Bestop, Inc. P.O. Box 307 2100 W. Midway Blvd. Broomfield, CO 80020-7115

49 CFR Part 573 Defect and Noncompliance Report

Bestop, Inc. Rear Shell Roof Rack - Bestop Part # 41400-01

Lattin Bracket, Oby - 1.

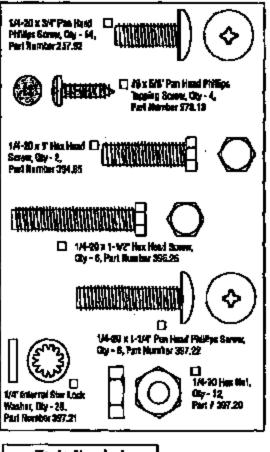
The cockpit cover may not stay latched to the roof rack because the latch bracket mispositions the rotary latch to the cockpit cover. (Attached is the cover page from the Rear Shell Roof Rack Installation Instructions that shows the cockpit cover in place in one drawing and stored on the roof rack in the second drawing. Also attached is the Parts List and Hardware Identification page from the Installation Instructions. The affected latch bracket and striker plates are circled on the parts list.)

The mounting holes for the screws that fasten the latch bracket to the cockpit cover are in the wrong location. This allows the rotary latch that mounts to the other side of the latch bracket to be mispositioned on the cockpit cover.

The mispositioning of the rotary latch on the cockpit cover prevents the striker plates from fully engaging the receiver brackets that secure the cockpit cover to the front cross rail. As a result, the cockpit cover may not stay latched to roof rack and could come off the roof rack.

Bestop will provide replacement parts consisting of an updated latch bracket and updated striker plates to all customers who purchased the Rear Shell Roof Rack. The updated latch bracket and updated striker plates will enable the striker plates to fully engage the receiver brackets that secure the cockpit cover to the front cross rail.

The replacement latch bracket will have mounting holes located closer to the edge of the bracket that is fastened to the cockpit cover than the recalled component to ensure that the rotary latch is correctly positioned on the cockpit cover. The replacement striker plates will have mounting holes that have a longer slot than the recalled component to allow for greater adjustment of the striker plates on the cockpit cover.
